STAFF RECOMMENDATION

2012 Cedar Lane

Application: Revision to Permit – Application to not demolish garage

Description of Project: The applicant is asking for a revision to a prior permit. At issue is retaining an existing garage which was originally to be demolished.

Figure 3. Site plan indicating removal of garage.

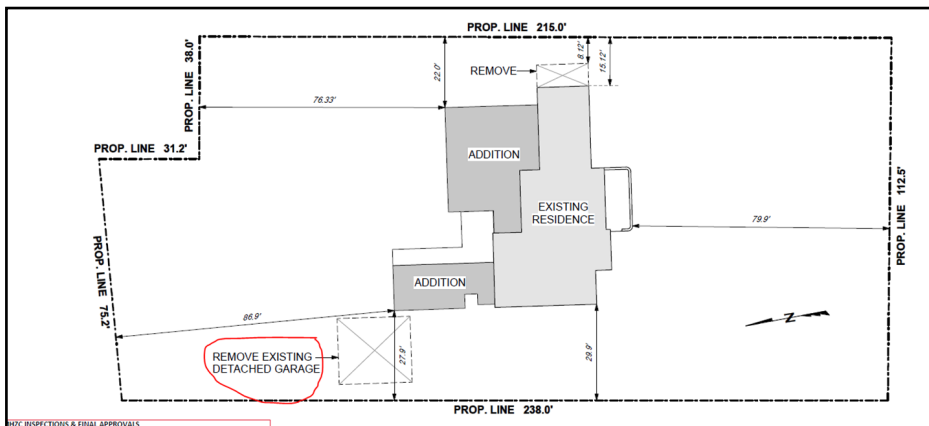
Analysis and Findings: The addition was approved by the Commission with the understanding that the existing outbuilding would be removed, as indicated on the site plan. (Figure 3) The design guidelines clearly indicate that there should be twenty feet (20') of distance between

outbuildings and primary structures. The Commission has reduced this on occasion - although never to less than three feet (3') - where there were site constraints, etc. This property has no such constraints. Staff would not have recommended approval of the addition in this location if the garage was not indicated for removal.

The design guidelines do say that an appropriate location for a garage is in the original location of a garage on the property. While this garage has been in this location for years

(staff has been unable to conclusively date it), it has always been over twenty feet (20') from the back of the house. The construction of the addition changes the context of this location. While staff rarely asks that a property owner demolish any existing structure, in this case, the construction of the addition has made the existing location of the garage inappropriate.

Recommendation Summary: Staff recommends disapproval of the permit revision, finding that it does not meet section II.B.1.i of the design guidelines for the Belmont-Hillsboro Neighborhood Conservation Zoning Overlay.

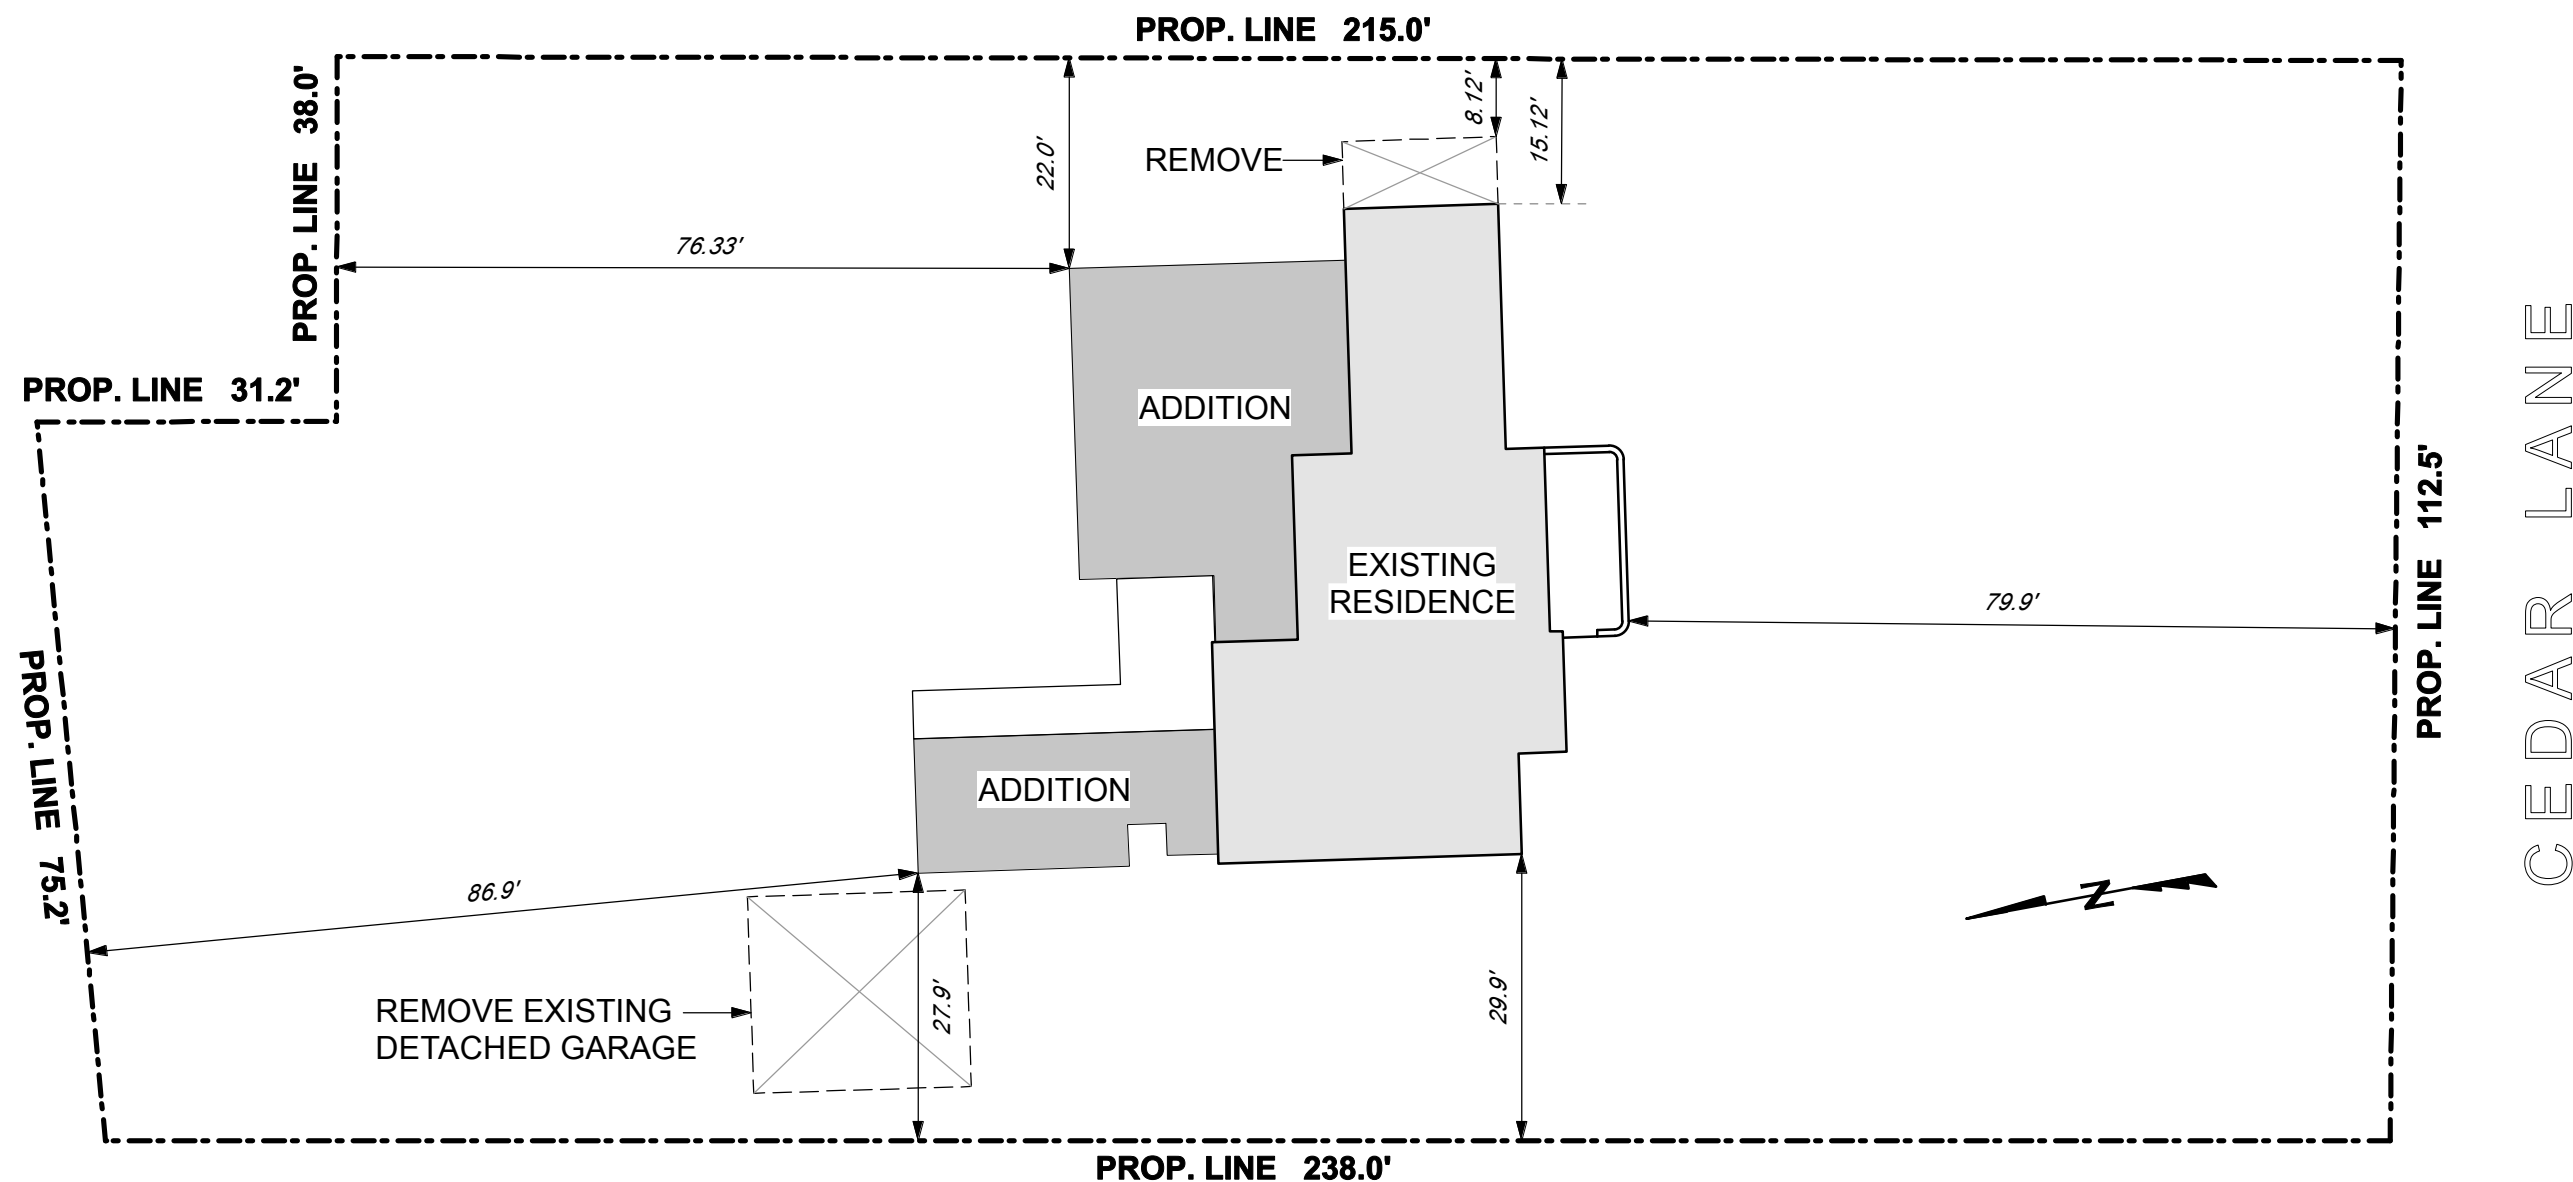
Background: In 2020, the Commission approved an addition to the contributing house at 2012 Cedar Lane. The approved addition has now been mostly constructed. The site plan indicated that the existing garage, located less than three feet from the addition, would be demolished. The garage is still in place and the applicant would like to retain it, rather than demolish it.
